Development Services Staff Report

File Number	PL2020-134
File Name	Continued PRELIMINARY DEVELOPMENT PLAN – Lee's Summit R-7 Middle School #4
Applicant	DLR Group
Property Address	1001 SE Bailey Rd
Planning Commission Date	July 23, 2020
Heard by	Planning Commission
Analyst	Hector Soto, Jr., AICP, Planning Manager
Checked By	Kent D. Monter, PE, Development Engineering Manager

Tree Size. Modification requested.

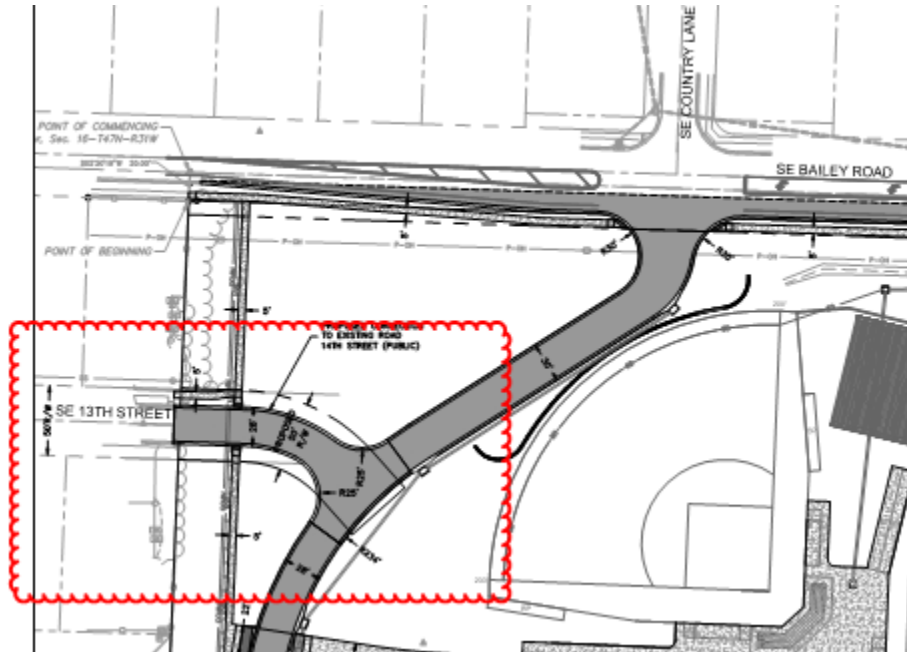
- Required – Deciduous trees shall be a minimum 3" caliper in size at the time of planting.
- Proposed – 2" caliper deciduous ornamental trees
- Recommended – The UDO's minimum 3" caliper size requirement applies to deciduous trees as a whole. The minimum size requirement applies equally to shade trees as it does to ornamental trees. Based on feedback the City has received from the development community, typical landscape nursery stock of ornamental trees is 2" caliper in size. The City has also received feedback from landscape professionals that the survivability of 2" caliper ornamental trees is significantly greater than that of larger ornamental trees. Given this information, Staff supports the request to allow 2" caliper deciduous ornamental trees.

1. A modification shall be granted to the minimum 3” deciduous tree caliper size, to allow 2” caliper ornamental trees.
2. Two monument signs with an overall height of 8’-10”, a sign face area of 40 sq. ft. and a sign structure area of 77 sq. ft. shall be allowed along SE Bailey Rd as depicted on the preliminary development plan.

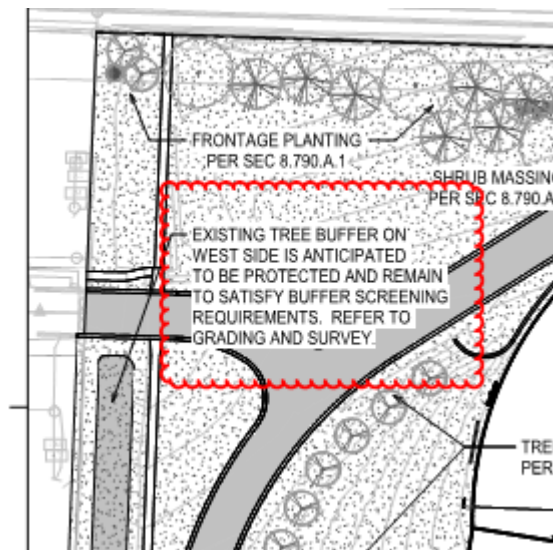
- **Can the existing treeline along the west project boundary adjacent to the Newberry subdivision be retained?**

Current plans call for the protection and retention of the existing treeline to serve as a buffer between the abutting developments.
